MRPL Marketing Terminal Project at Devangonhi, Bangalore Marketing Infrastructure Projects, MRPL.	
	LSTK-A PACKAGE : TANKAGE AND ASSOCIATED CIVIL, MECHANICAL, PIPING, ELECTRICAL, INSTRUMENTATION & FIRE FIGHTING WORKS ADDENDUM 05

ADDENDUM 05

MRPL Tender No. 3200000495 dated 26.03.2021

ANNEXURE 01 –TECHNICAL ADDENDUM

DRAWING TITLE:
PIPING AND INSTRUMENTATION DIAGRAM PLT MANIFOLD

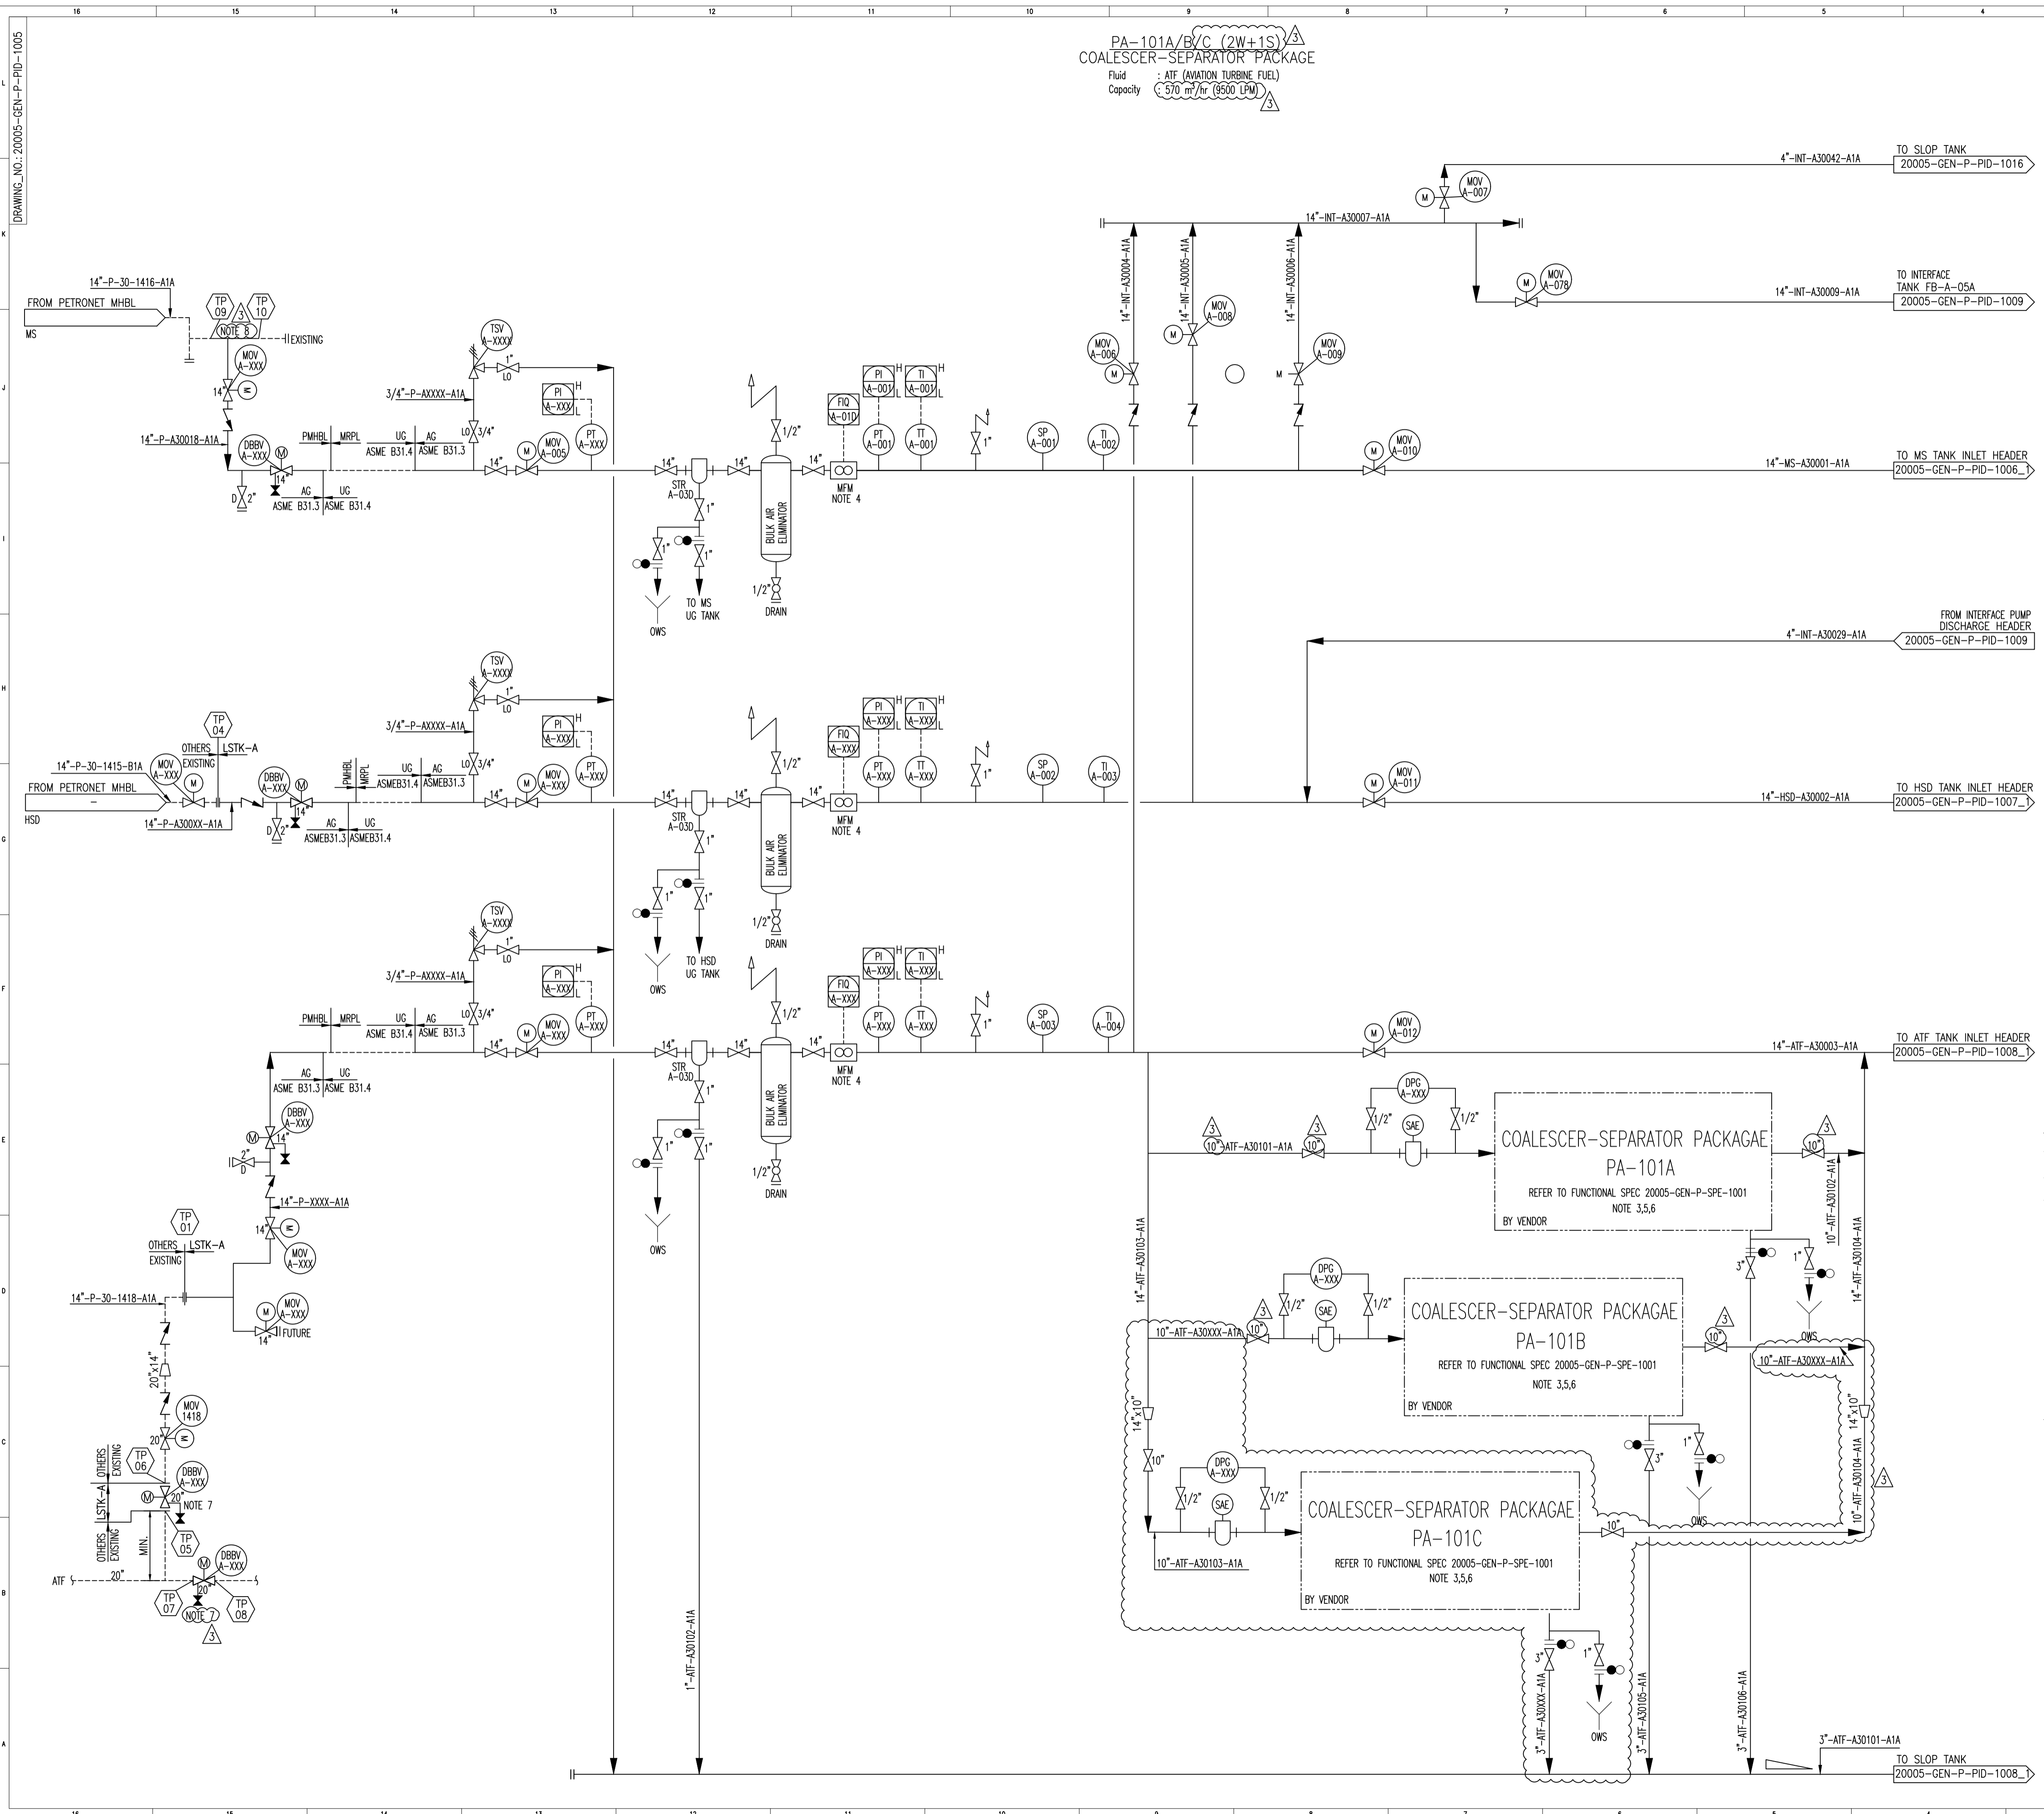
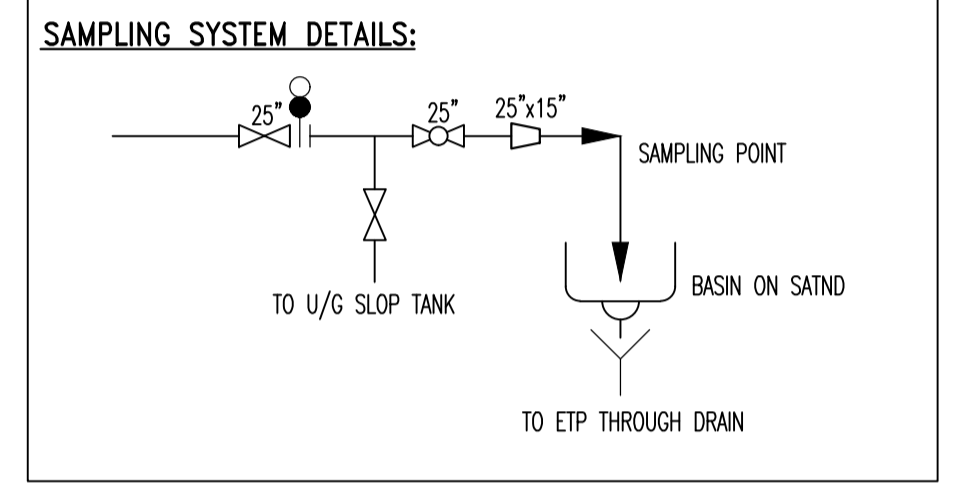
3.	Volume II, Technical Section Part 30	D.38	3267 of 3638	20005-GEN-P-PID-1005 Rev 2.	<u>Modification</u> Replaced with Rev. 1 20005-GEN-P-PID-1005 Rev 3.

PA-101A/B/C (2W+1S)
 COALESCER-SEPARATOR PACKAGE
 Fluid : ATF (AVIATION TURBINE FUEL)
 Capacity : 570 m³/hr (6500 LPM)

4.2.1 Package units PA-101A/101B for ATF product on Receipt line

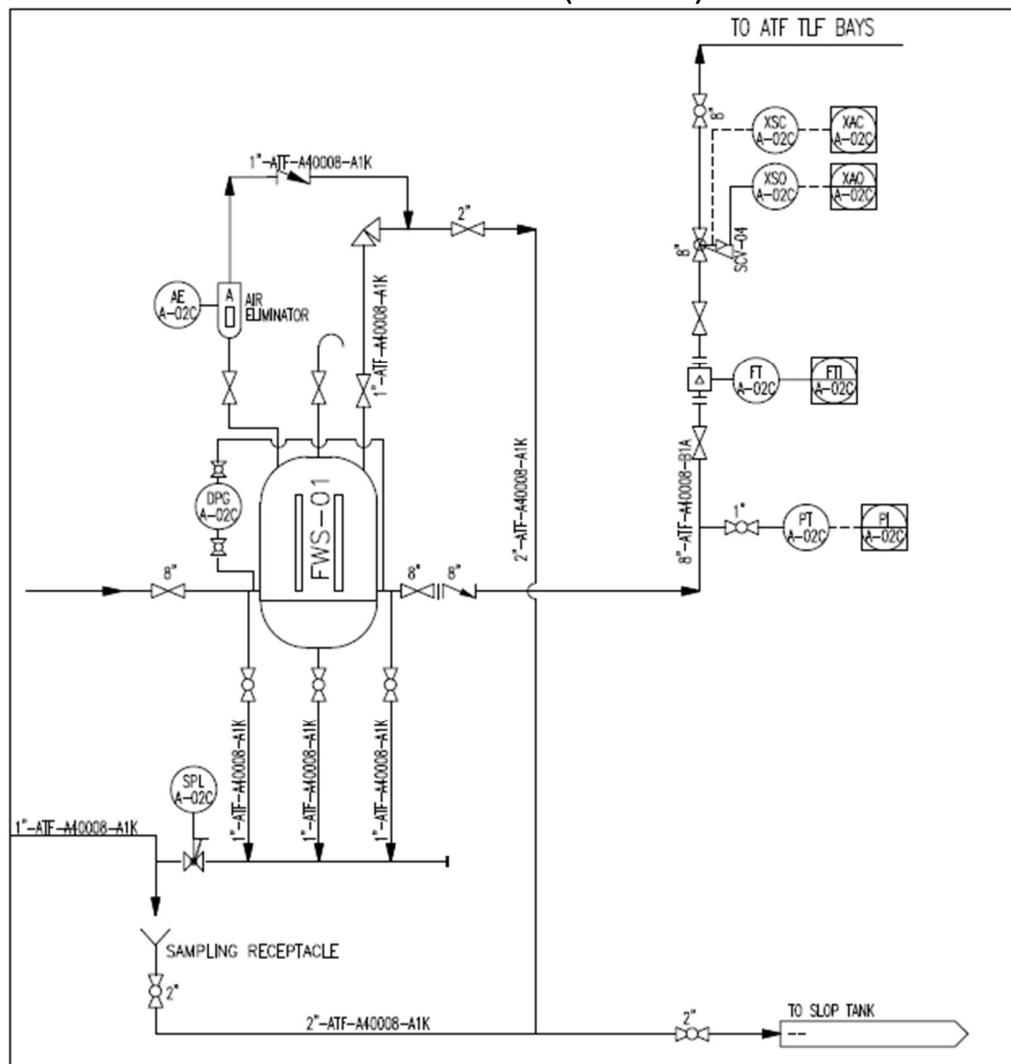
Coalescer-separator-filter package units PA-101A/B/C (2W+1S) with design flow rate of 570 m³/h (9500 LPM) shall be provided on the ATF receipt pipeline in PLT Manifold to ATF storage tanks.
